A d d e n d u m

Iowa Department of Transportation
Office of Contracts

B.O.	Proposal ID	Proposal Work Type	County	Project Number	Addendum
501	57-1001-081	CLEARING & GRUBBING	LINN	NHSN-100-1(81)--2R-57	19NOV501.A01

TREE FELLING
NHSN-100-1(81)-2R-57

SHEET NUMBER D.16

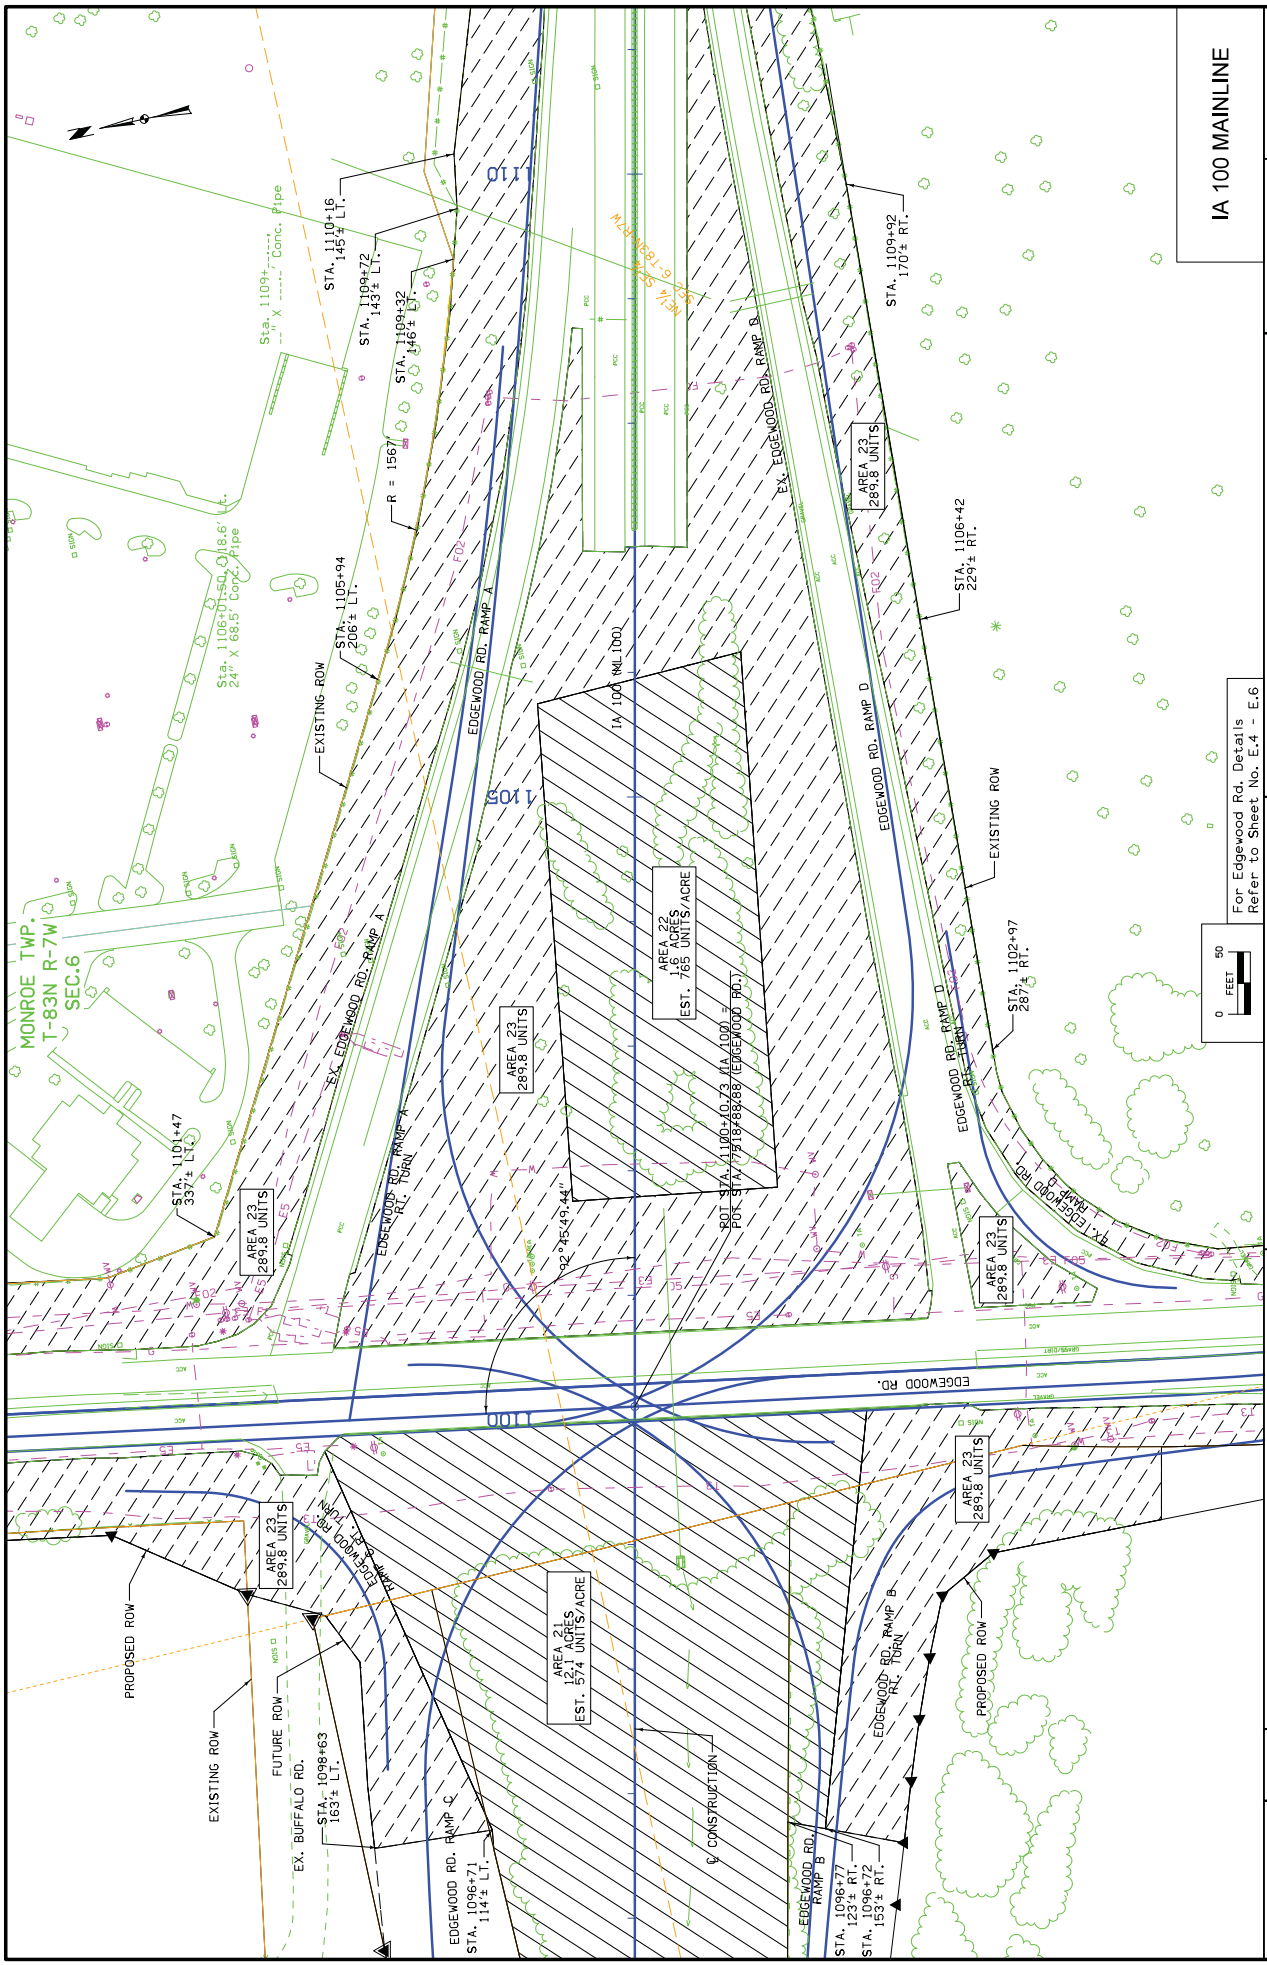
Replace Sheet D.16 with the attached Sheet D.7.
Updated Area 21 limits, quantity note, and associated callouts
Updated Area 23 limits

ENGLISH	DATE	DESIGN TEAM	Iowa DOT\CH2MHILL	PROJECT NUMBER	NHSN-100-1(81)-2R-57	SHEET NUMBER	E.3
2013\11\01	Jwehl			LINN COUNTY

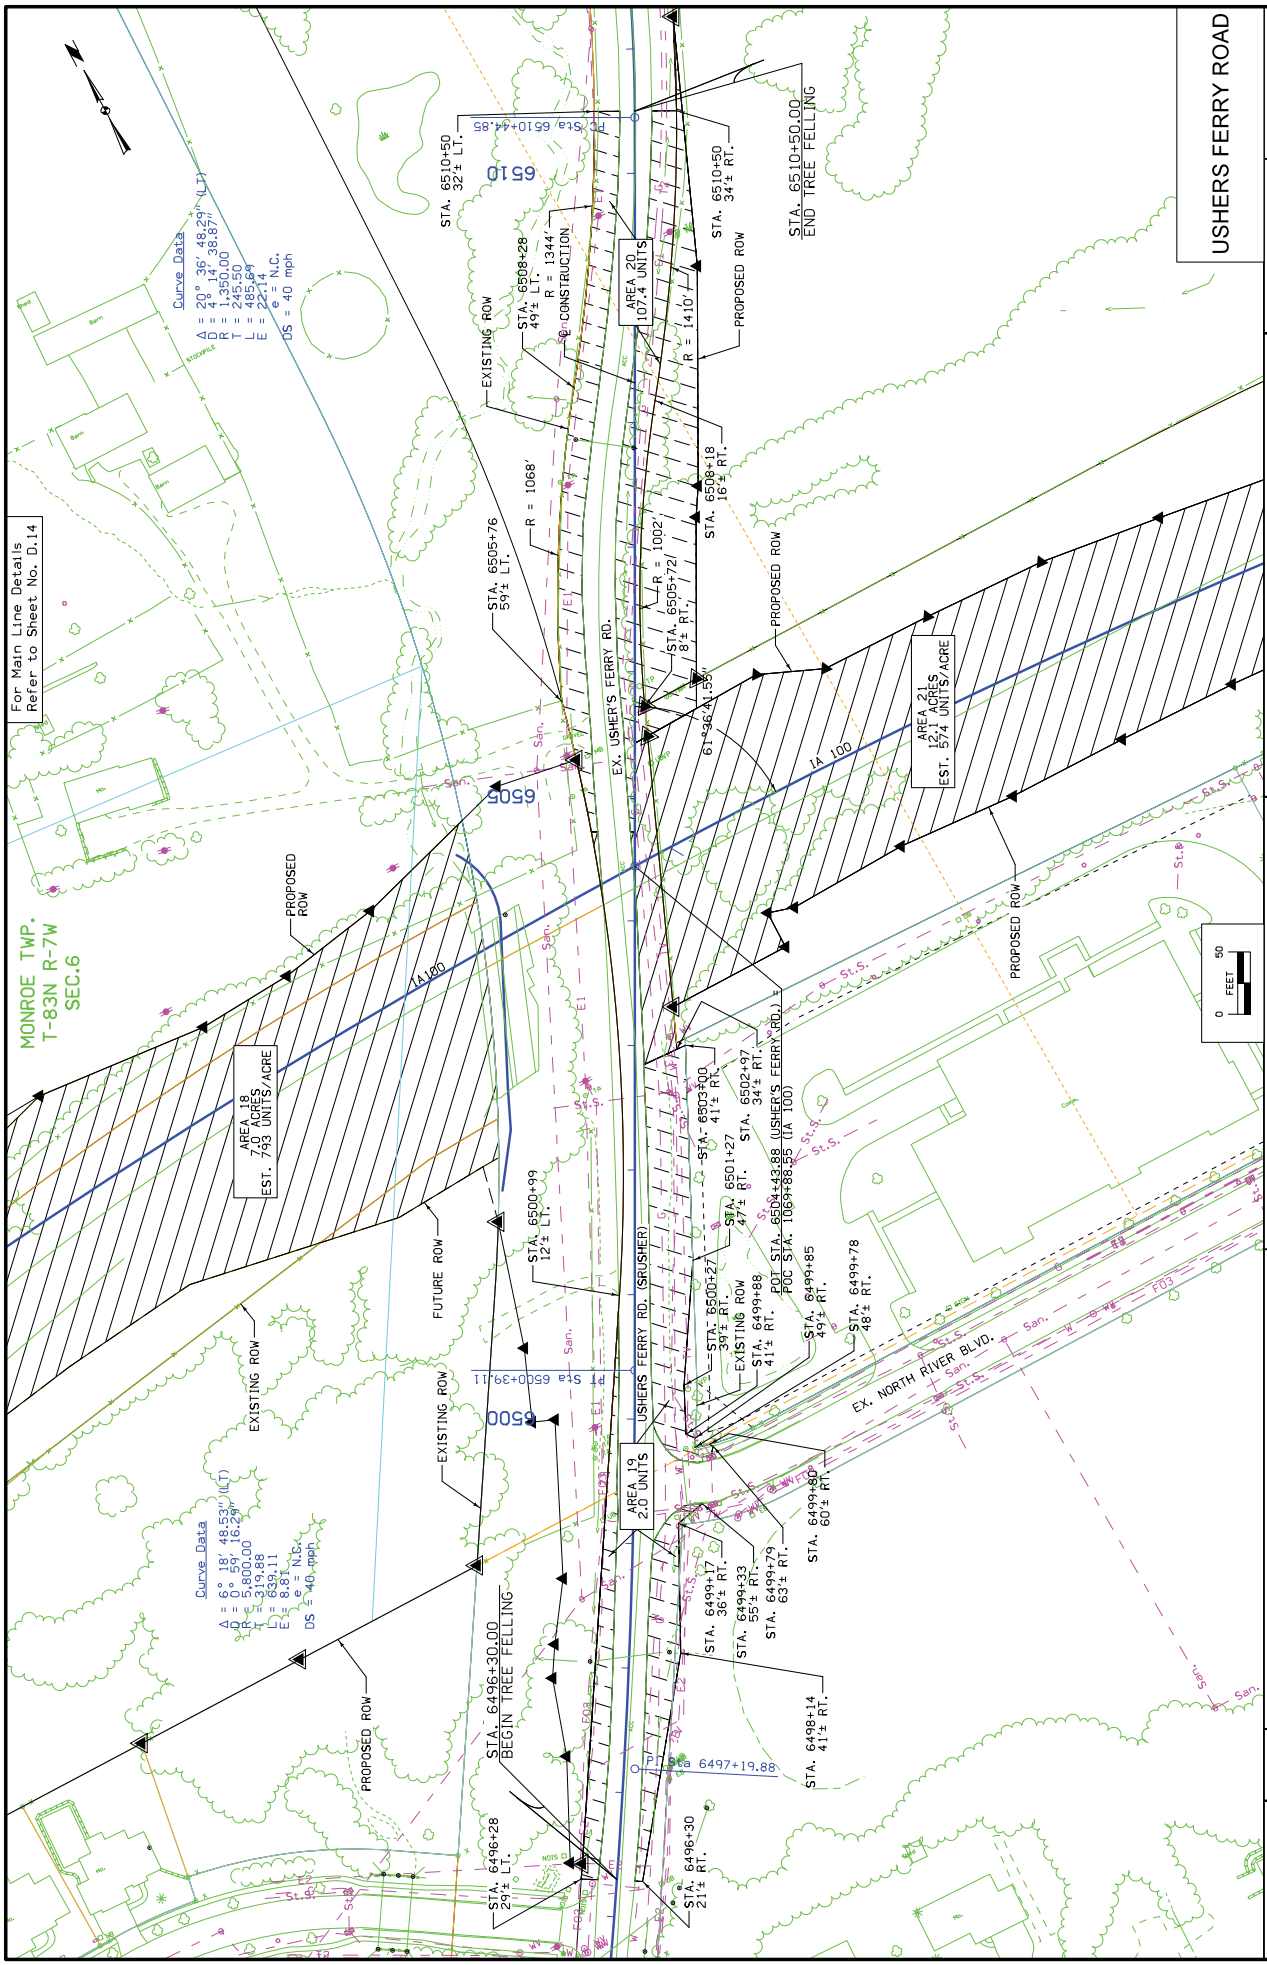
Replace Sheet E.3 with the attached Sheet D.7.
Updated Area 21 note

C ENGLISH 2013/11/01 Jwehrl	IOWA DOT DESIGN TEAM Jwehrl	IOWA DOT CH2MHILL	LINN COUNTY PROJECT NUMBER N15710008	E.5 SHEET NUMBER 15710008
--------------------------------------	-----------------------------------	----------------------	--	---------------------------------

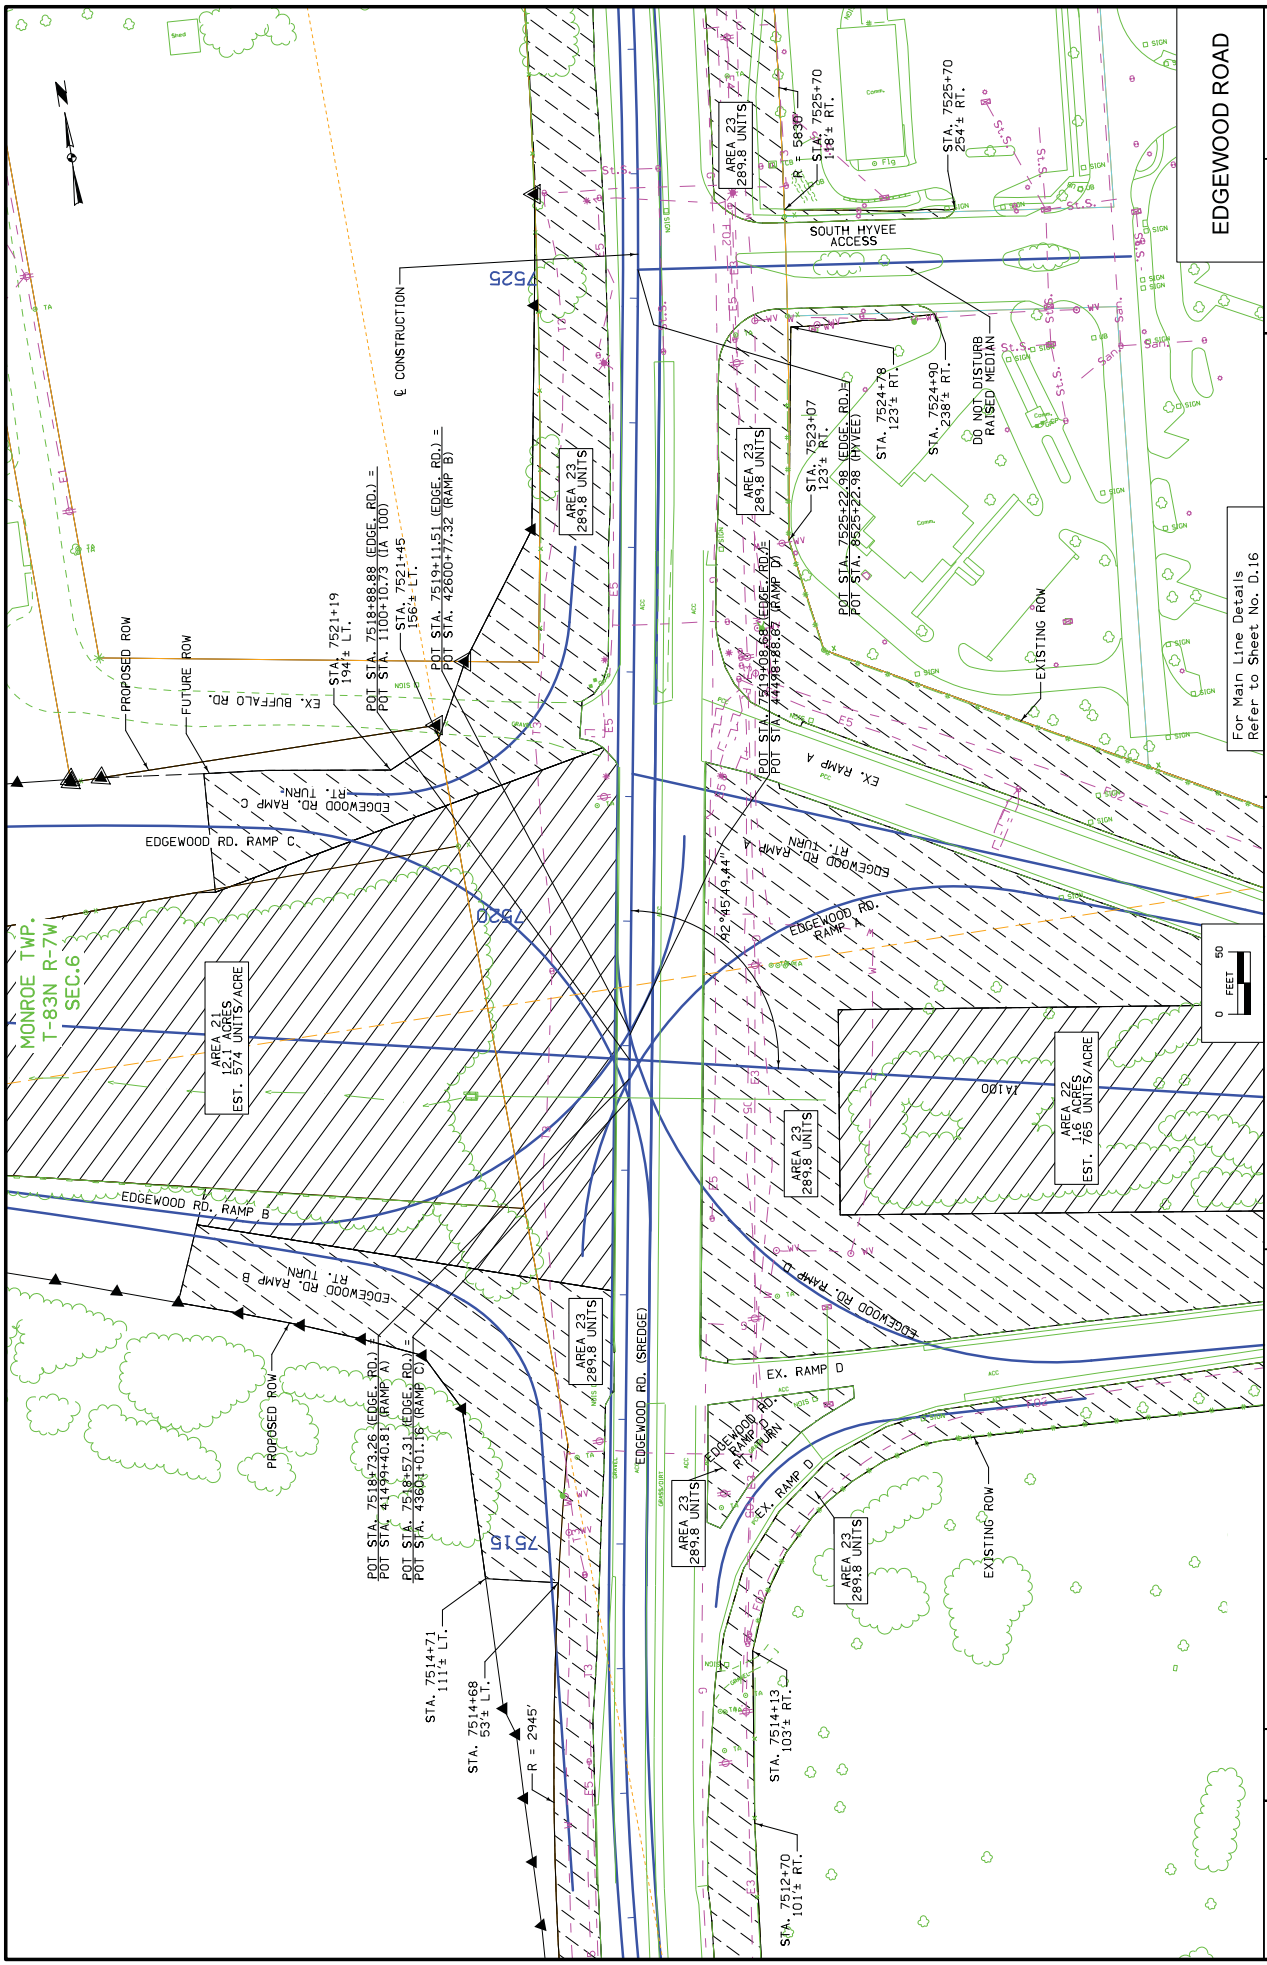
Replace Sheet E.5 with the attached Sheet D.7.
Updated Area 21 limits, quantity note, and associated callouts
Updated Area 23 limits
